| Architect | Michael Fitzpatrick (MFA) |
| Project | Drumclark Development Co. Cavan |
| Title | Quality Audit Response |
| Dwg. No. | D111-CSC-XX-XX-DR-C-0025 |

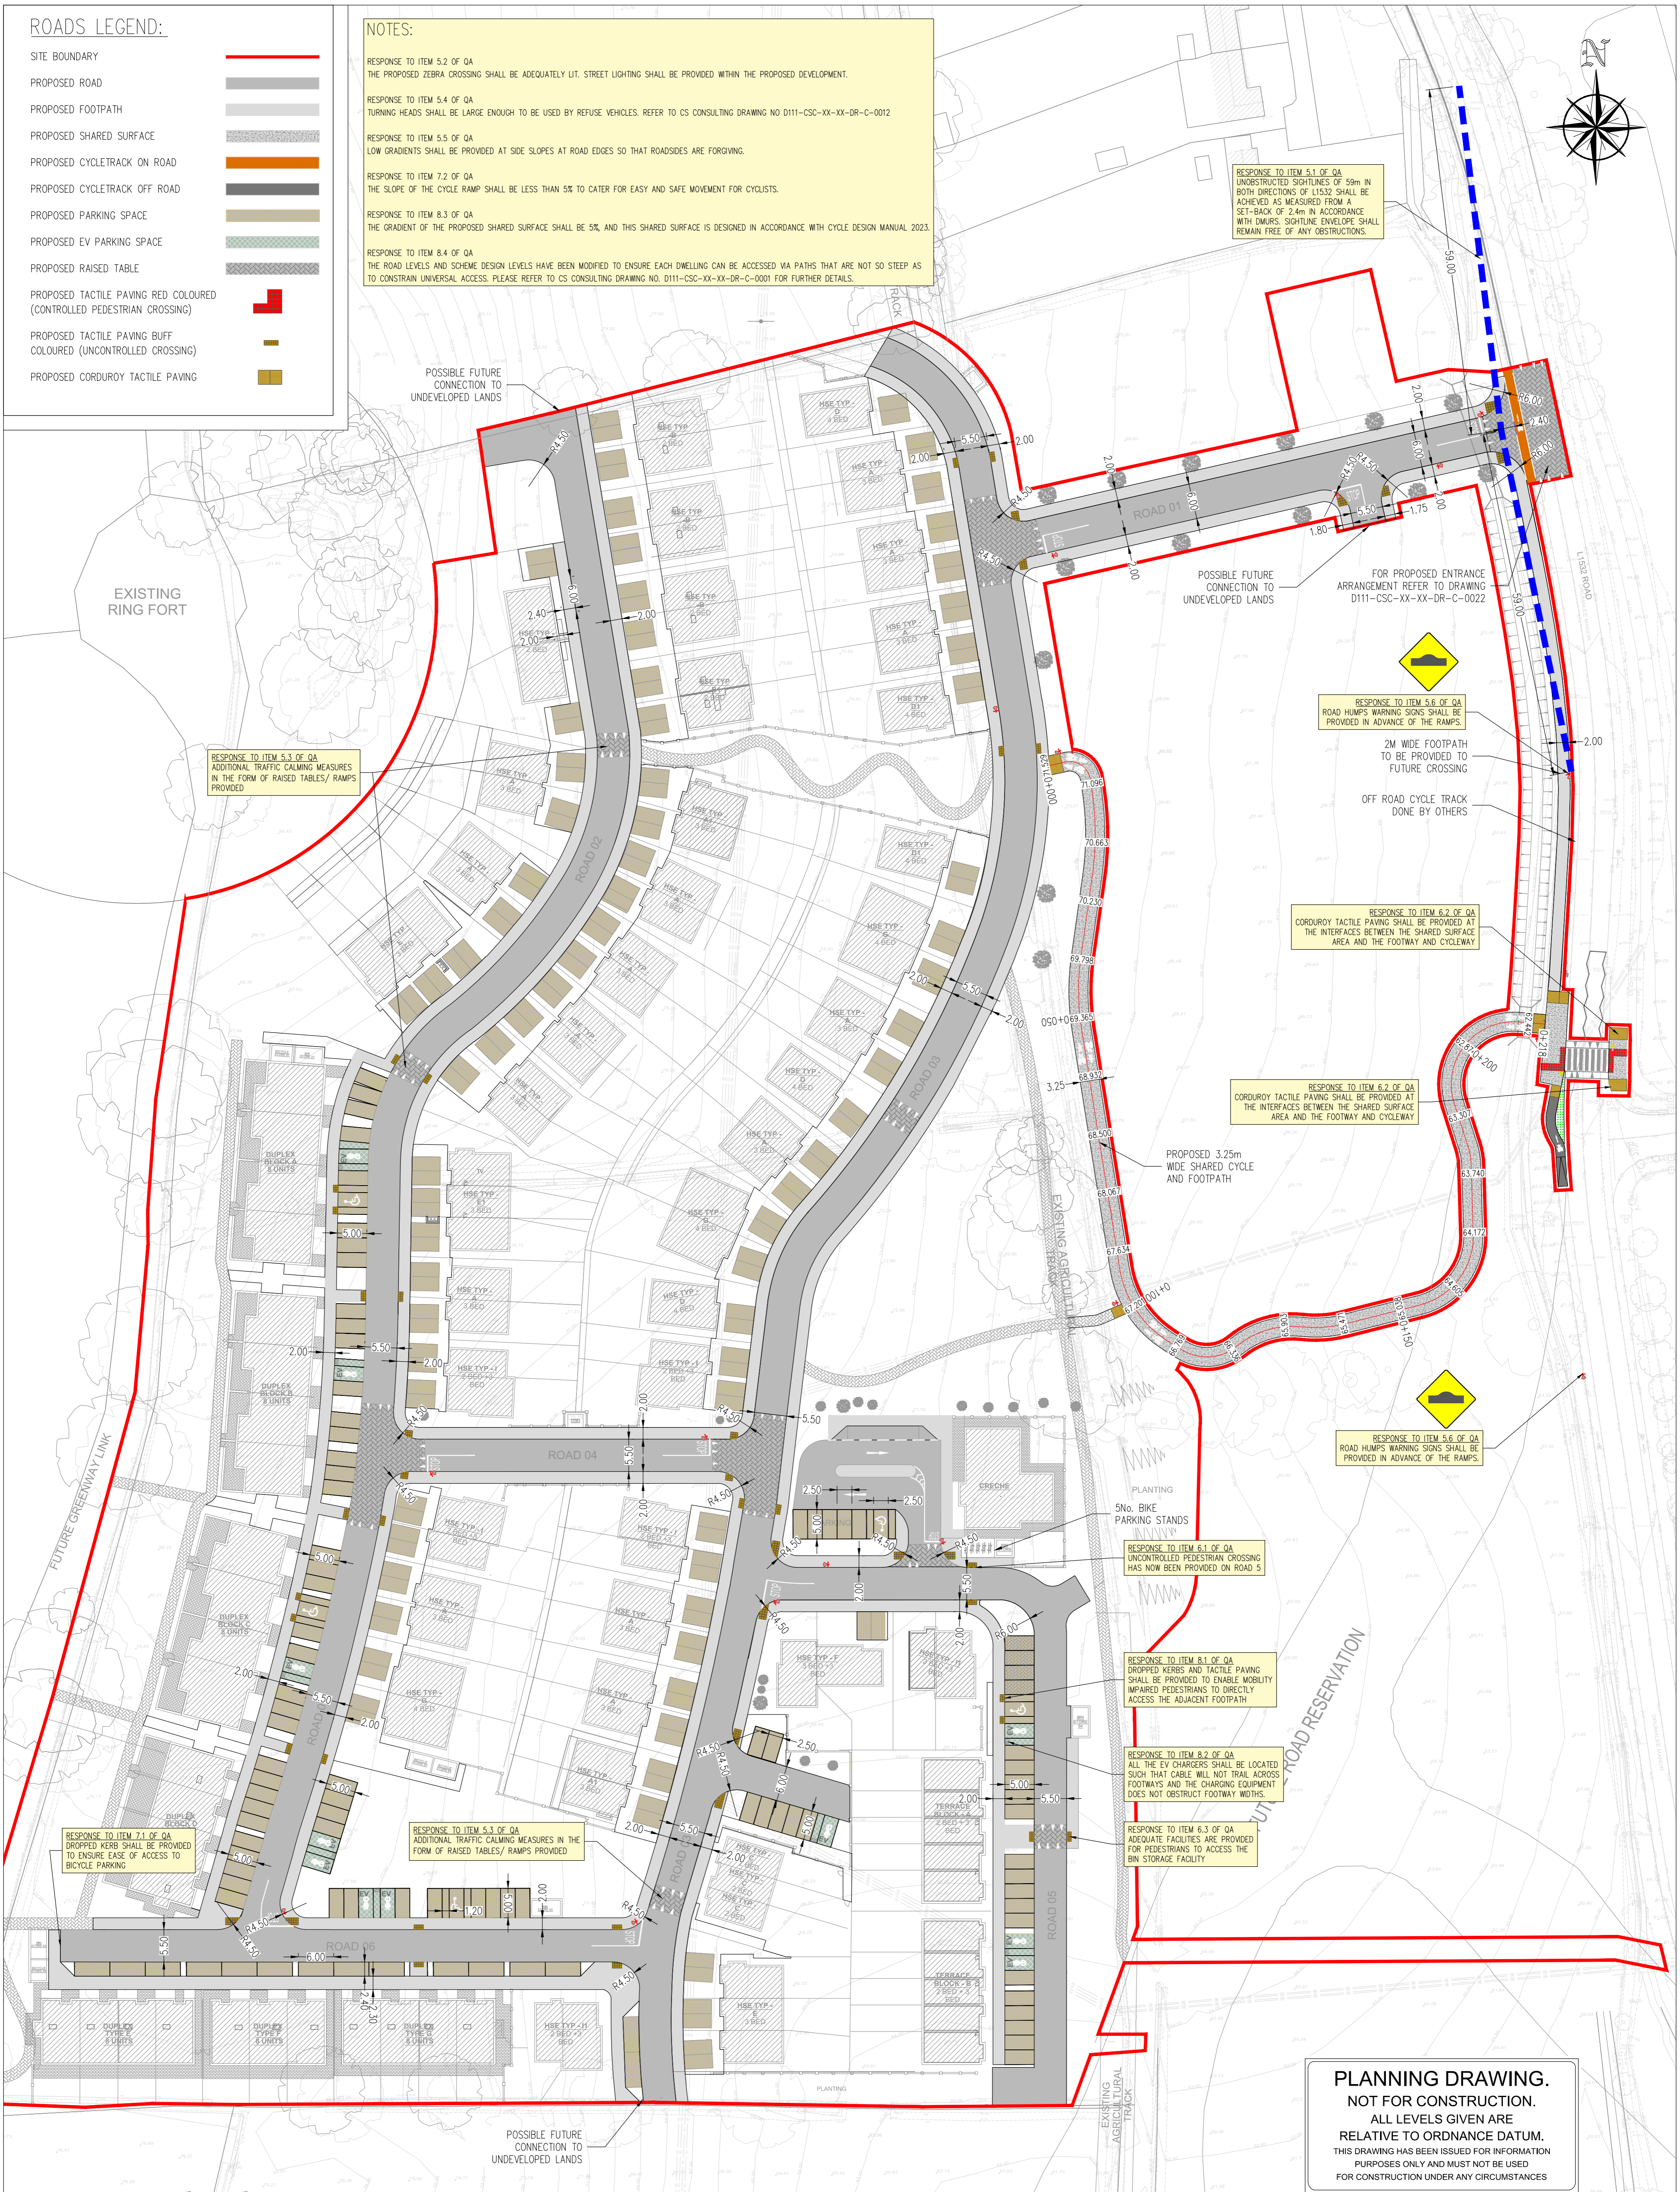
- RESPONSE TO ITEM 5.2 OF QA
THE PROPOSED ZEBRA CROSSING SHALL BE ADEQUATELY LIT. STREET LIGHTING SHALL BE PROVIDED WITHIN THE PROPOSED DEVELOPMENT.
- RESPONSE TO ITEM 5.4 OF QA
TURNING HEADS SHALL BE LARGE ENOUGH TO BE USED BY REFUSE VEHICLES. REFER TO CS CONSULTING DRAWING NO D111-CSC-XX-XX-DR-C-0012

- RESPONSE TO ITEM 5.5 OF QA
LOW GRADIENTS SHALL BE PROVIDED AT SIDE SLOPES AT ROAD EDGES SO THAT ROADSIDES ARE FORGIVING.
- RESPONSE TO ITEM 7.2 OF QA
THE SLOPE OF THE CYCLE RAMP SHALL BE LESS THAN 5% TO CATER FOR EASY AND SAFE MOVEMENT FOR CYCLISTS.

- RESPONSE TO ITEM 8.3 OF QA
THE GRADIENT OF THE PROPOSED SHARED SURFACE SHALL BE 5%, AND THIS SHARED SURFACE IS DESIGNED IN ACCORDANCE WITH CYCLE DESIGN MANUAL 2023.

- RESPONSE TO ITEM 8.4 OF QA
THE ROAD LEVELS AND SCHEME DESIGN LEVELS HAVE BEEN MODIFIED TO ENSURE EACH DWELLING CAN BE ACCESSED VIA PATHS THAT ARE NOT SO STEEP AS TO CONSTRAIN UNIVERSAL ACCESS. PLEASE REFER TO CS CONSULTING DRAWING NO. D111-CSC-XX-XX-DR-C-0001 FOR FURTHER DETAILS.

RESPONSE TO ITEM 5.1 OF QA
UNOBSTRUCTED SIGHTLINES OF 59m IN BOTH DIRECTIONS OF L1532 SHALL BE ACHIEVED AS MEASURED FROM A SET-BACK OF 2.4m IN ACCORDANCE WITH DMURS. SIGHTLINE ENVELOPE SHALL REMAIN FREE OF ANY OBSTRUCTIONS.

RESPONSE TO ITEM 5.3 OF QA
ADDITIONAL TRAFFIC CALMING MEASURES IN THE FORM OF RAISED TABLES/ RAMPS PROVIDED

RESPONSE TO ITEM 5.6 OF QA
ROAD HUMPS WARNING SIGNS SHALL BE PROVIDED IN ADVANCE OF THE RAMPS.

RESPONSE TO ITEM 6.2 OF QA
CORDUROY TACTILE PAVING SHALL BE PROVIDED AT THE INTERFACES BETWEEN THE SHARED SURFACE AREA AND THE FOOTWAY AND CYCLEWAY

RESPONSE TO ITEM 8.1 OF QA
UNCONTROLLED PEDESTRIAN CROSSING HAS NOW BEEN PROVIDED ON ROAD 5

RESPONSE TO ITEM 8.1 OF QA
DROPPED KERBS AND TACTILE PAVING SHALL BE PROVIDED TO ENABLE MOBILITY IMPAIRED PEDESTRIANS TO DIRECTLY ACCESS THE ADJACENT FOOTPATH

RESPONSE TO ITEM 8.2 OF QA
ALL THE EV CHARGERS SHALL BE LOCATED SUCH THAT CABLE WILL NOT TRAIL ACROSS FOOTWAYS AND THE CHARGING EQUIPMENT DOES NOT OBSTRUCT FOOTWAY WIDTHS

RESPONSE TO ITEM 8.3 OF QA
CIRCULATE FACILITIES ARE PROVIDED FOR PEDESTRIANS TO ACCESS THE BIN STORAGE FACILITY

RESPONSE TO ITEM 7.1 OF QA
DROPPED KERB SHALL BE PROVIDED TO ENSURE EASE OF ACCESS TO BICYCLE PARKING
